MIL R-83536/6
AMENDMENT 2
15 December 1995
SUPERSEDING
AMENDMENT 1
22 September 94

MILITARY SPECIFICATION SHEET

RELAYS ELECTROMAGNETIC, ESTABLISHED RELIABILITY 4PDT
LOW LEVEL TO 5 AMPERES PERMANENT MAGNET DRIVE, HERMETICALLY SEALED,
ALL WELDED, TRANSIENT SUPPRESSED DC COILS

This amendment forms a part of MIL-R-83536/6, dated 27 March 1992, and is approved for use by all Departments and Agencies of the Department of Defense

CIRCUIT DIAGRAM (NO MOUNT, RVFM, HFH AND TRACK MOUNT A)
(OPTIONAL INTERNAL
DIODE CONFIGURATION)

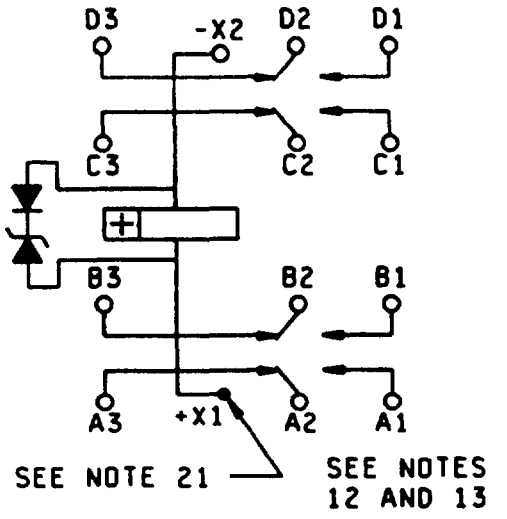
• Add the following circuit diagram
